Historic Preservation Board

**STAFF MEMORANDUM
HISTORIC PRESERVATION PROGRAM
PLANNING AND URBAN DEVELOPMENT**

TO: Chair O'Brien and Members of the Historic Preservation Board
FROM: Evan R. Schueckler, Historic Preservation Program Manager
DATE: December 30, 2022
RE: 11 O'Brien Street – SECOND WORKSHOP – Alterations
PROJECT ID: HPBR-002110-2022
MEETING: January 4, 2023

Existing Section at Dormer

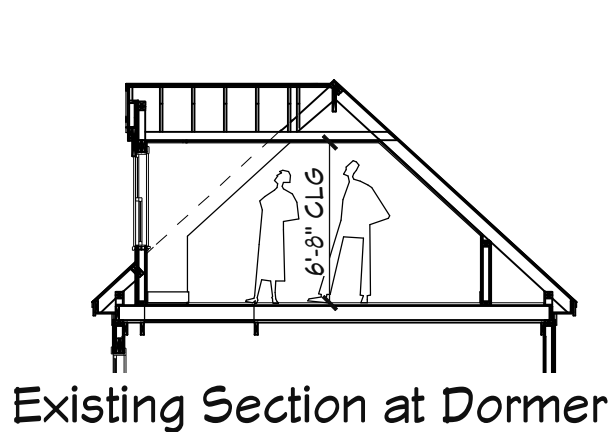
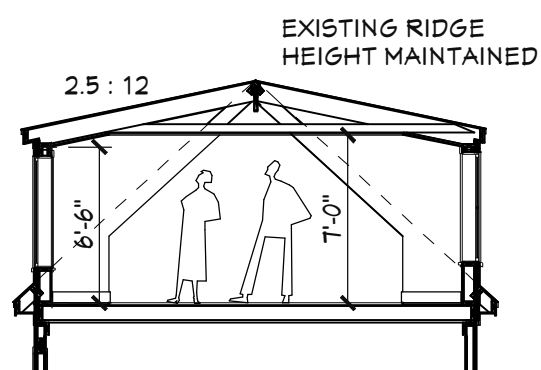
Before considering the revised dormer design, staff would recommend that the Board provide further consideration of whether the existing dormers are contributing features to the structure and provide clear guidance to the applicant on the appropriateness of their removal. The existing dormers appear to be original to the building, being shown in the 1924 tax photo. While the dormers have been clad in vinyl siding and aluminum trim/flushing, obscuring any historic trim or details and negatively impacting their integrity, they do retain their overall shape, massing, and fenestration pattern.

Standard 5	
Distinctive features, finishes, and construction techniques or examples of skilled craftsmanship which characterize a structure, object, or site shall be treated with sensitivity.	
Standard Met?	Staff Comments
For Board Discussion	The applicant is proposing to remove two historic gabled dormers at the south elevation and to replace them with two wider shed roof dormers. While these dormers are original to the structure, the Board may find that they are non-contributing to the structure. Additionally, the Board should consider that the material integrity of the dormers is limited given they have been covered with vinyl siding and metal flashing/trim obscuring any historic details.
